RE: Holiday Inn – Natomas Promenade (P17-033)

WALKSacramento has reviewed the project routing for Holiday Inn – Natomas Promenade (P17-033) and we offer the following comments. WALKSacramento provides these comments with the goal of improving the project's potential to support active living.

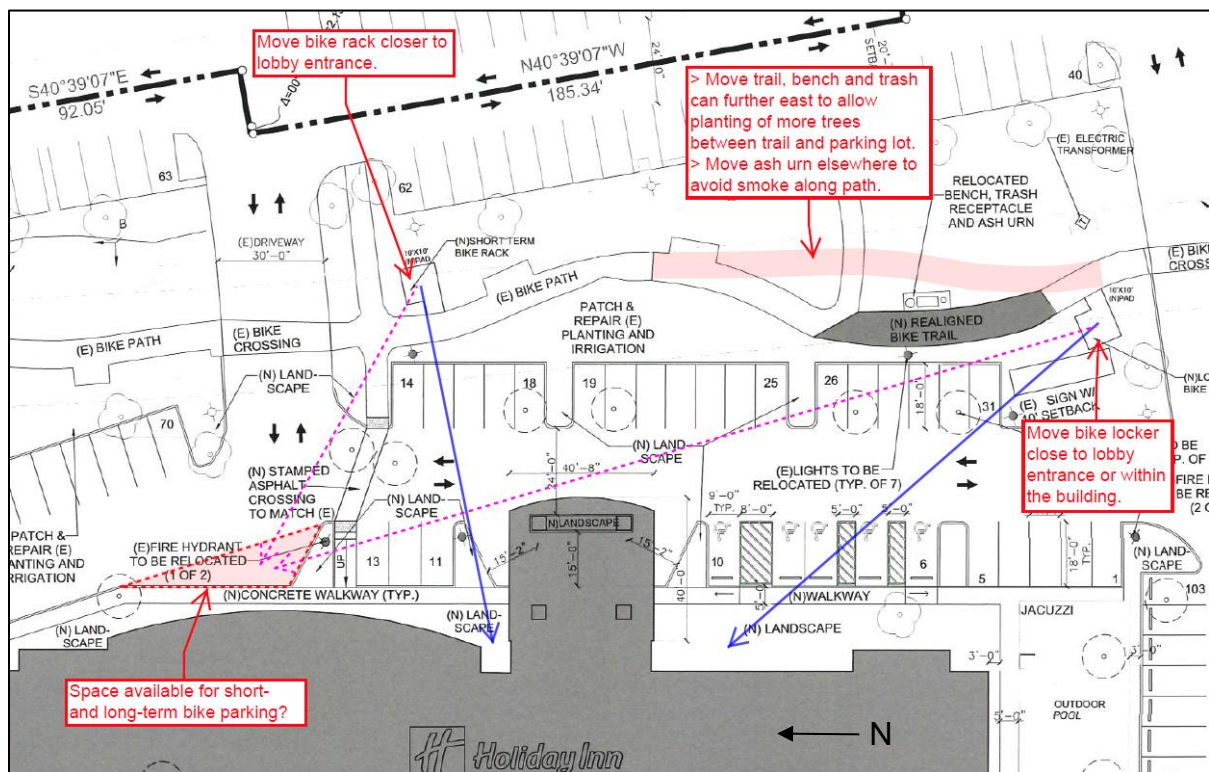
Bike parking should be convenient for bicyclists, and since the provided bike parking is for hotel guests and employees, the parking should be located close to the hotel building within direct view of occupants and people entering and exiting the building. Many people will not feel comfortable leaving their bike in a semi-public area on the other side of two rows of parking and

We've indicated on the following diagram potential locations for bike parking. There is a triangle-shaped area of driveway near the relocated fire hydrant (1 of 2) near the northeast corner of the building that might be utilized for both short- and long-term parking. The other possibilities are the landscaped areas to the north and south of the lobby entrance. To encourage greater active travel by bicycles, **WALKSacramento recommends moving the short-term and long-term bike parking to locations near the lobby entrance.**

Although the walkway, labeled (E) BIKE PATH on the site plan, that meanders through the landscaped area east of the building is primarily for pedestrians, it also provides access to the bike trail that runs along the southern border of Sacramento Gateway. The project already proposes to realign a portion of the walkway by moving it several feet east. If the walkway was moved another 15' to 20' there would be room for additional trees between the walkway and the parking lot. This would shade the walkway from the west side which is a benefit to pedestrians, and it would provide additional shading of the parking lot which reduces micro-heat island effects helping to reduce localized temperature and auto cold soak emissions.

Planting trees on the west side of the walkway will create a more pleasant landscape right outside the entrance to the hotel, but the area could be even more attractive to hotel guests if there were trees on the east side of the walkway, too. It appears there's room for additional trees between the walkway and the parking lot to the east (spaces numbered 40-60 on the site

At the south of the walkway there's an existing colored stamped concrete crosswalk, labeled (E) Bike Crossing on the site plan, that leads to the east-west bike trail on the southern edge of Promenade at Sacramento Gateway. Unfortunately, there's no connection made to the bike trail as the south end of the crosswalk abuts a vertical curb and there's no hardscape surface between the curb and the bike trail. See image below.

WALKSacramento recommends the project realign the north-south walkway “(E) BIKE PATH” so that it’s generally centered lengthwise in the landscaped area, add shade trees to the extent possible on the east and west sides of the walkway, and construct a curb ramp and sidewalk to that connects the north-south walkway to the off-site east-west bike trail.
